Appln. No.: 10/500,205  
Amendment dated August 3, 2007  
Response to Office Action mailed May 3, 2007

### **REMARKS/ARGUMENTS**

## Annotated Sheet

**Fig.1**

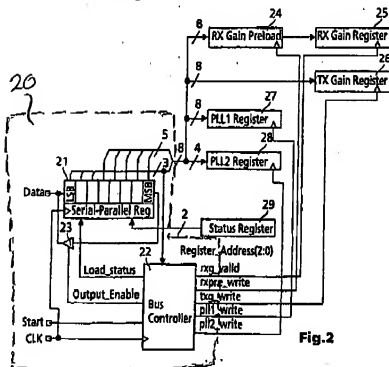
In the Office Action, the Examiner objects to the drawings under 37 C.F.R. 1.83(a) because they fail to show "serial bus connection 19" and "bus interface 20."

Applicants submit herewith a Replacement Sheet for FIGS. 1 and 2, showing serial bus connection 19 and bus interface 20. Applicants also submit a marked-up copy of the original drawing sheet, labeled as "Annotated Sheet," showing the changes to FIGS. 1 and 2 to add serial bus connection 19 and bus interface 20.
